UNITED STATES
NUCLEAR REGULATORY COMMISSION

SUBJECT: JUNE 2-4, 2003, MEETING SUMMARY: MEETING WITH DUKE
COGEMA STONE & WEBSTER TO DISCUSS CHEMICAL SAFETY
RELATED TO MIXED OXIDE FUEL FABRICATION FACILITY

**MEETING SUMMARY
MOX FUEL FABRICATION FACILITY
June 2-4, 2003**

The purpose of the meeting was to discuss the draft Safety Evaluation Report (SER) chemical safety open items related to the construction authorization request (CAR) for the MOX Fuel Fabrication Facility (MFFF).

**Resulting Airborne Concentration as a Function of Wind Speed Over the Spill
(500 liters of 13.6 N Nitric Acid Spilled over 50 sq. m)**

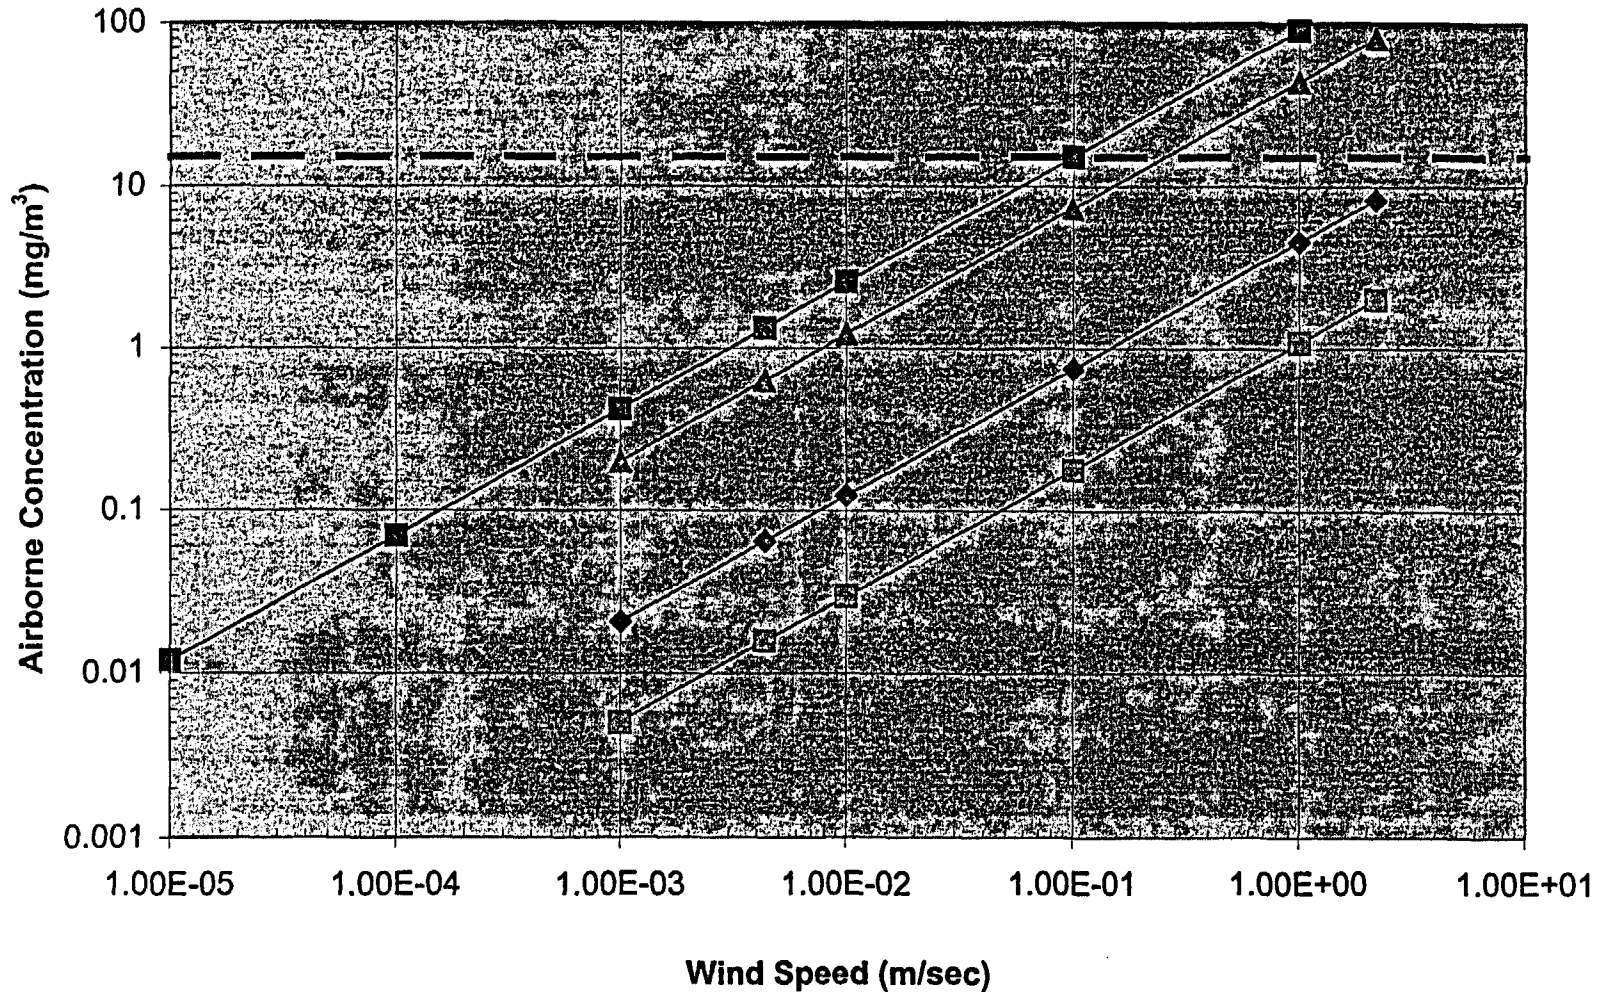
This item involved the effect of indoor airspeed on the calculational model used for determining whether a hot nitric acid spill in a cell could result in exceeding the performance criteria in 10 CFR Part 70. The applicant determined that for an uncontained spill and an average indoor airspeed of 0.01 m/sec, no consequence limits would be exceeded. The staff was concerned that the 0.01 m/sec airspeed was not realistic due to possible air duct locations near floor level that could significantly affect the evaporation rate of an uncontained spill. Specifically, the evaporation model is very sensitive to airspeed above the spill and an increase to 1 m/sec could exceed the low consequence limits. Additionally, the evaporation rates increase with temperature and could be substantial for temperatures above 110°C.

The staff conducted independent calculations using three different techniques (the guidance in NUREG/CR-6410, Nuclear Fuel Cycle Facility Accident Analysis Handbook, ALOHA and EPICode) and determined that the indoor air speed would conservatively have to be greater than a factor of five times the assumed average wind speed of 0.01 m/sec. to exceed the ERPG-2 value for a hot nitric acid spill (119°C) in the C-105 cell floor to exceed the low consequence limits for the site worker. The calculations assumed that the spill covered the entire 60m² floor area and did not take into account the conservative effects of the spill catch pan under the tank that is designed to contain the entire tank volume, or cooling from contact with the floor surface.

In addition to the above, DCS will do a cell by cell review during the ISA to confirm that low consequence limits will not be exceeded for any uncontained spill. Should the limit be exceeded, DCS indicated that the existing spill catch pan, already a principal structure systems and component (PSSC) for other scenarios, would be upgraded to a PSSC for this scenario. Since (1) there is a substantial indoor airspeed margin, (2) a cell by cell review will be conducted during the ISA, and (3) should the low consequence limits be exceeded for any cell assuming an uncontained spill (i.e., no catch pan), the applicant will upgrade the existing devices to PSSCs without impact on any construction activities, the staff considers this item closed.
